ASSESSMENT REPORT

S79C – Environmental Planning & Assessment Act 1979

DA No:	DA/571/2014
Assessment Officer:	Denise Fernandez
Property:	158 - 164 Hawkesbury Road WESTMEAD and 2A Darcy Road WESTMEAD
Proposal:	Demolition of five buildings, tree removal, bulk earthworks, construction of roads and Torrens title subdivision of the site into 5 allotments. Approval is also sought for building envelopes on the site.
Date of receipt:	28 August 2014
Applicant:	JBA Urban Planning Consultants
Owner:	University of Western Sydney
Submissions received:	One
Property owned by a Council employee or Councillor:	No
Political donations/gifts disclosed	None disclosed on the application form
Issues:	Height and FSR – Clause 4.6 lodged for the variations.
Recommendation:	Deferred Commencement

Figure 13 – FSR LEP Map
Source: PLEP

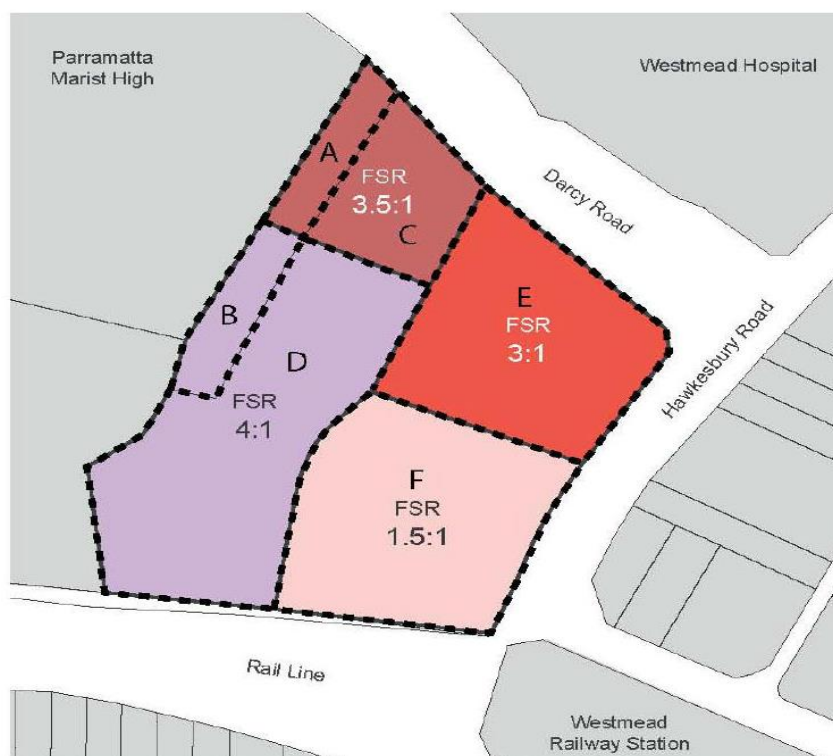
The permissible FSR varies across the site from 1.5:1 to 3:1 to 3.5:1 to 4:1 as shown in **Figure 13** below.

The FSR for each individual development lot is significantly higher than the PLEP controls (as shown in **Table 2**). However, the lot boundaries do not correspond to the FSR boundaries. Instead, when the proposed GFA is allocated within the FSR boundaries the proposal generally complies with the standard. Notwithstanding, there is some variation and this is shown in **Table 6** below. It is also noted that the areas of the parcels identified in the FSR LEP Map have been calculated by overlaying the map on the Cox Richardson Master Plan. Accordingly, the areas are not based on any technical survey information, and it is therefore considered that the resulting FSRs are approximate only.

The non-compliance is considered to be acceptable representing a variation between 8.3% and 196.1% difference to the maximum FSR for the site. The plans show that the variation in the FSR does not in this case hinder compliance with solar access, views to and from the site and bulk and scale requirements of the Parramatta Development Control Plan 2011 for mixed use developments.
